CONFIRMATION
MEMO

PROJECT JO HERDT ADDITION DATE 2-6-84
JOB NO. _____
TO Chris Breitenstein
FROM N. Brent Wooten
REFERENCE Final Drainage Plan

1-5-84
Drainage plan

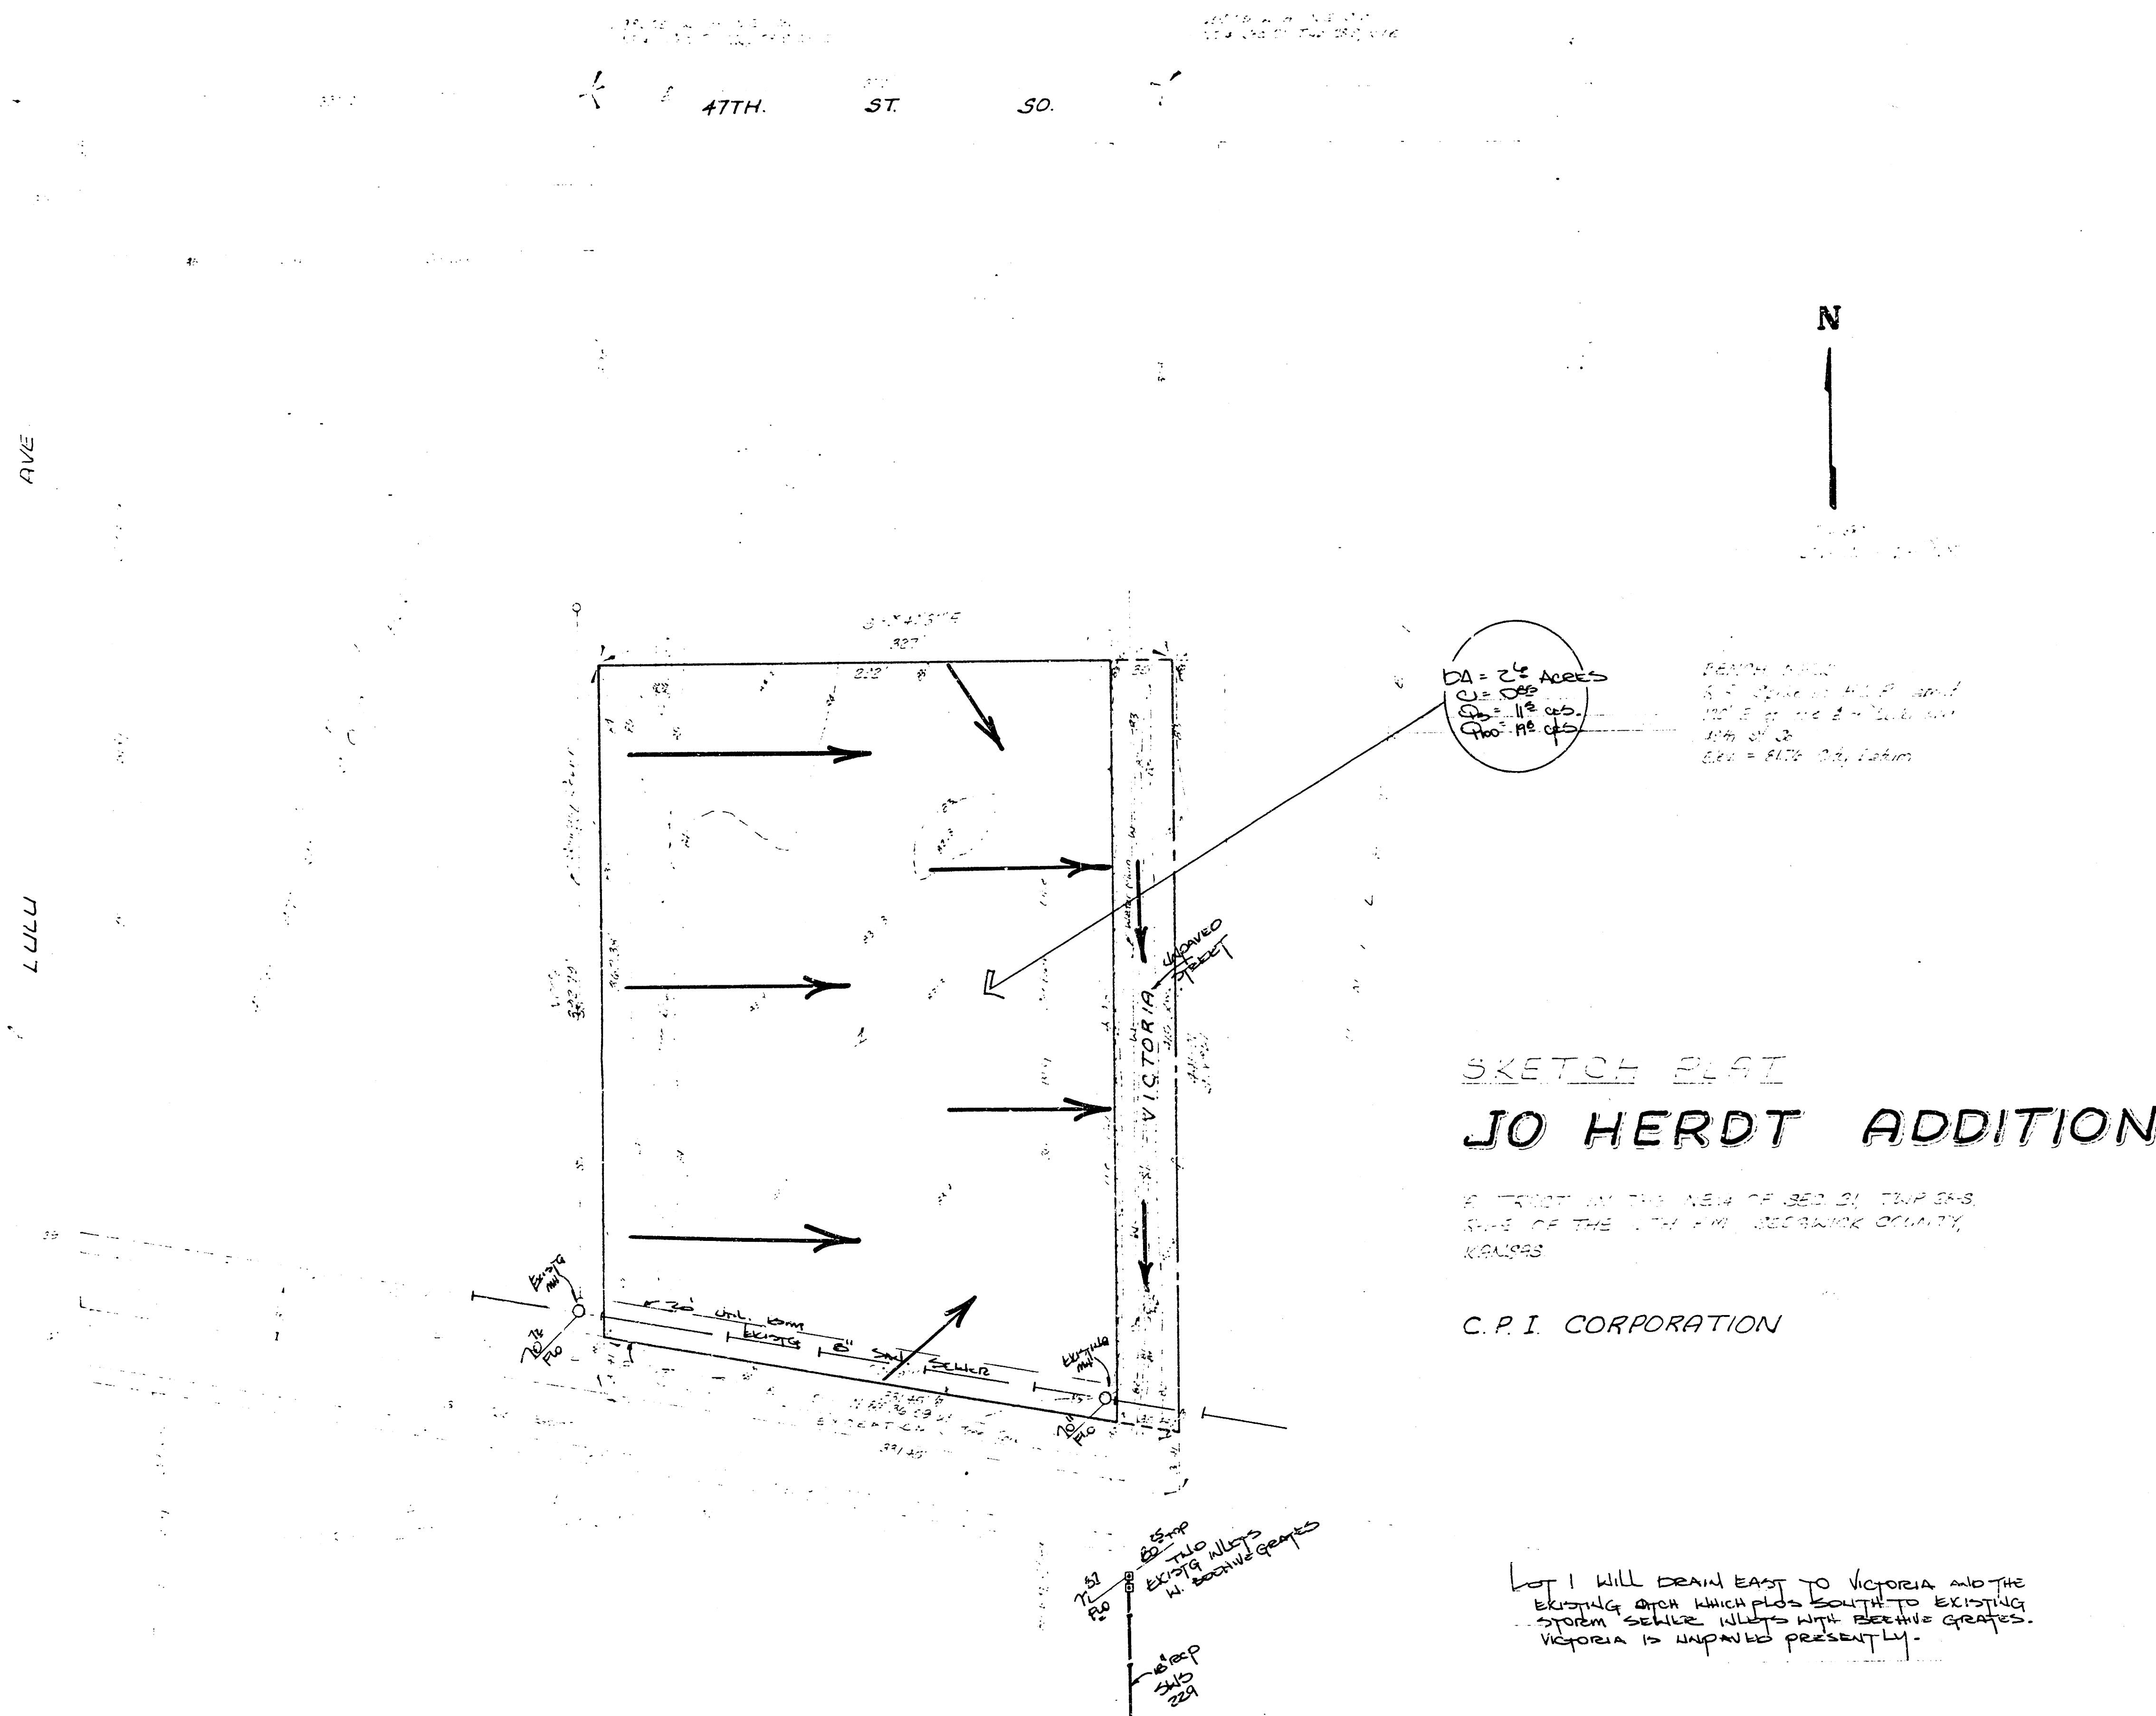
Draw to unpaved st.

B+C) drain to unpaved st.

OK with O+N?

Do we require guarantee to pave adjacent to plat?
